LINCOLN/LANCASTER COUNTY PLANNING COMMISSION STAFF REPORT

APPLICATION NUMBER Change of Zone 05061D	FINAL ACTION? No	DEVELOPER/OWNER Nebraska Horsemen's Benevolent and Protective Association
PLANNING COMMISSION HEARING DATE March 17, 2021	RELATED APPLICATIONS None	PROPERTY ADDRESS/LOCATION S. 1 st Street & W. Denton Road

Change of Zone #: CZ05061D
Southwest Village PUD
S 1st St & W Denton Rd

FACE SF	30% FACE SF	PROPOSED SIGNAGE SF
			1. 500 SF 2. 216 SF 716 SF
	32,880 SF	9,864 SF	0 SF

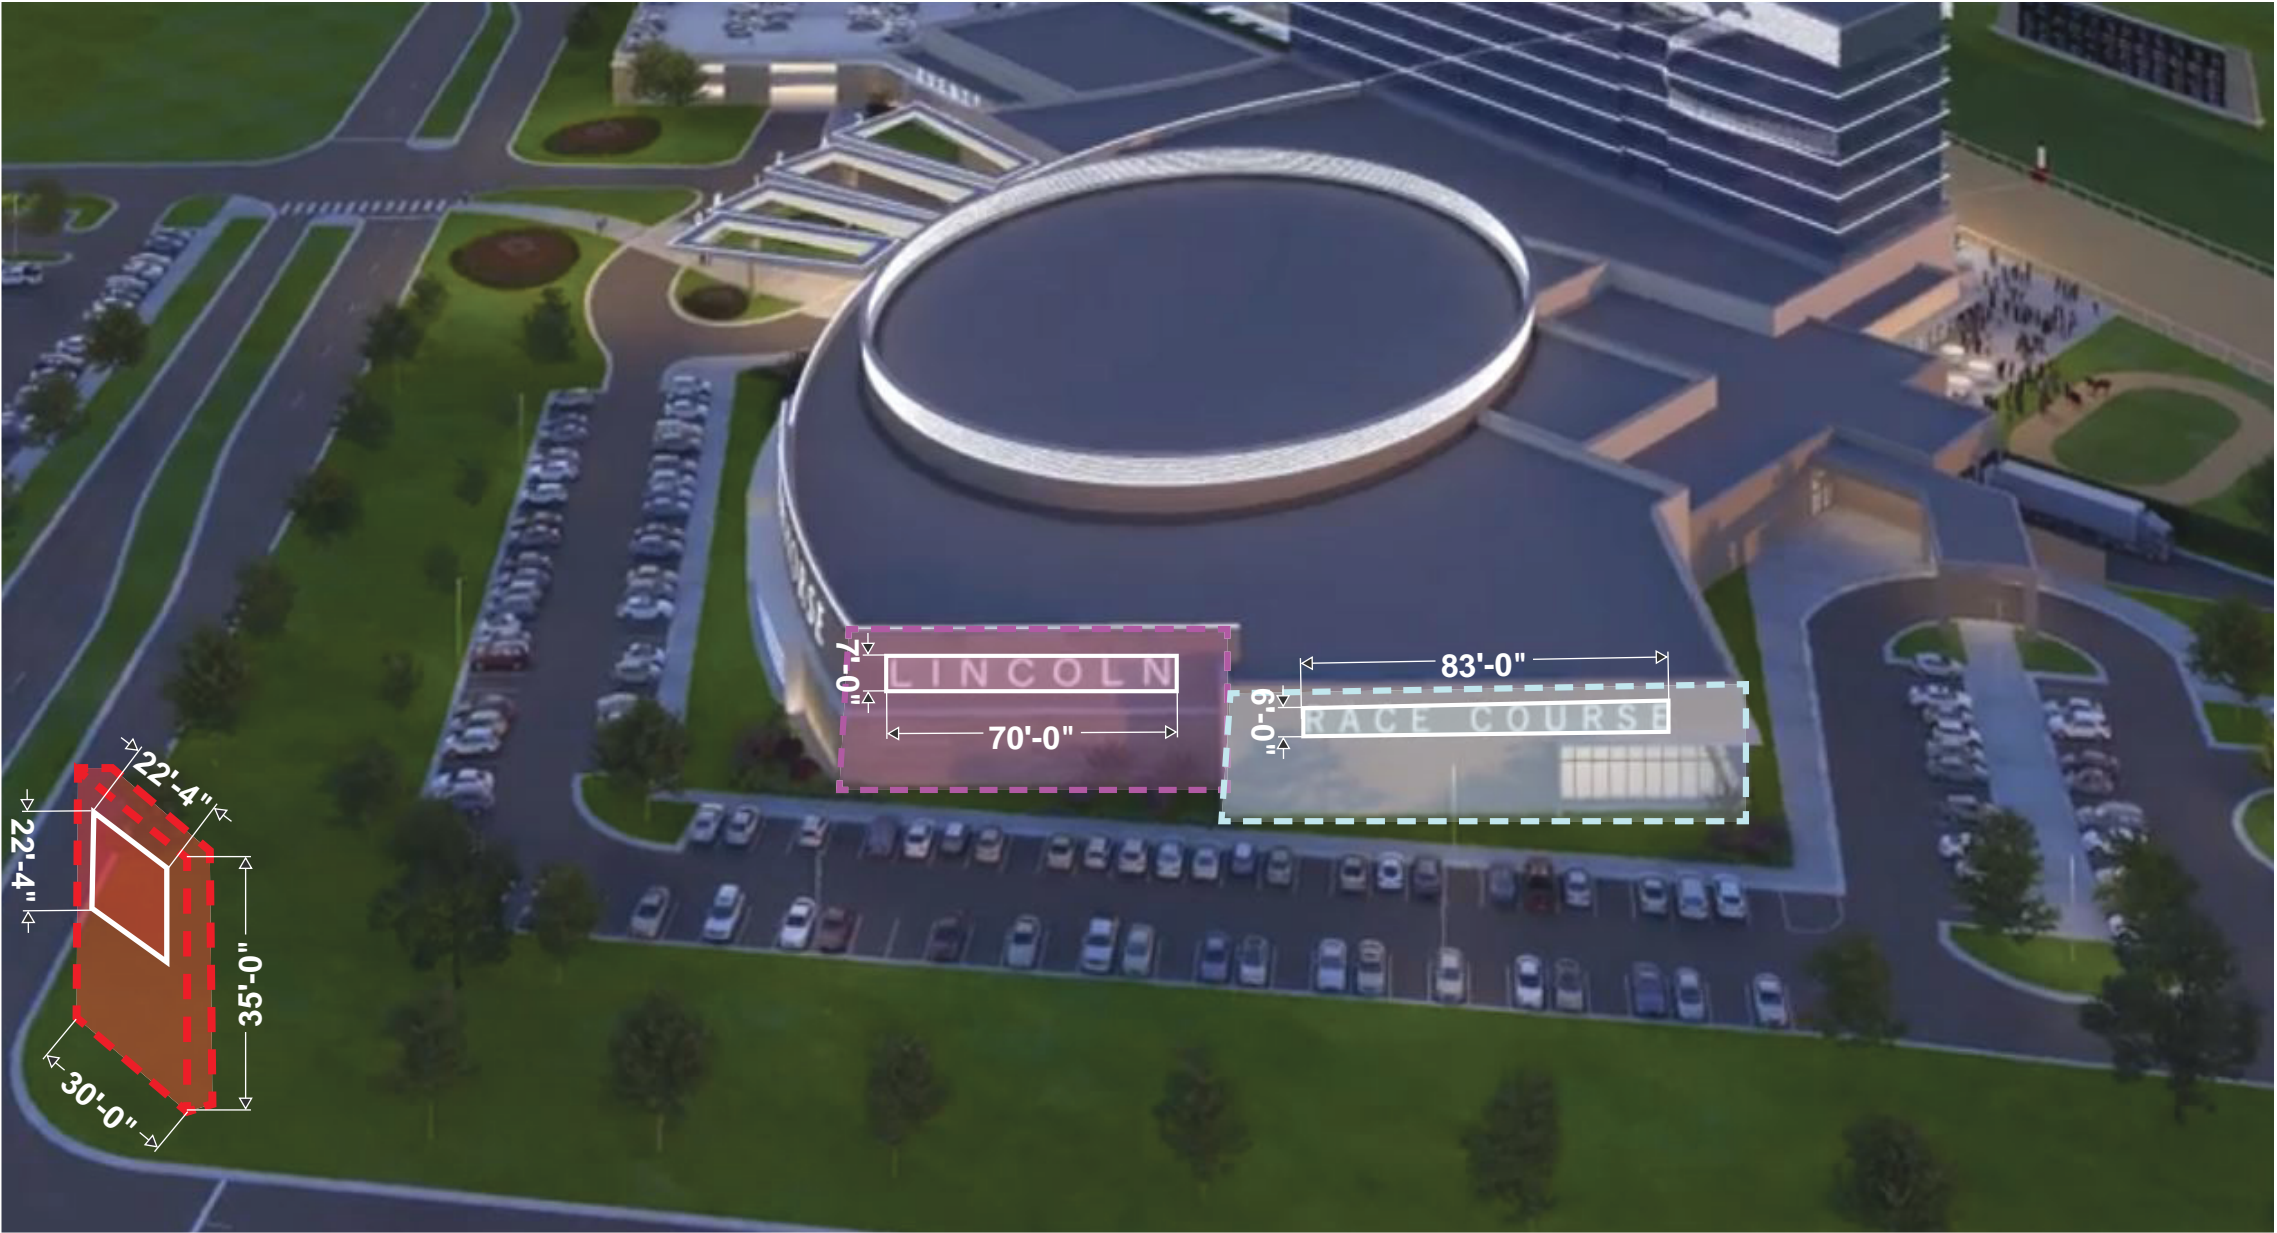
- 2.1 Submit the full amended plan set including sheets that were not changed, remove bubbling and strikeouts on the Cover Sheet notes.
 - 2.2 Revise the sign plan to reflect a maximum of 320 square feet of electronic changeable copy sign area for the 500 square foot center sign. For the center sign, delete the "FACE SF" and "30% FACE SF" categories in the table.
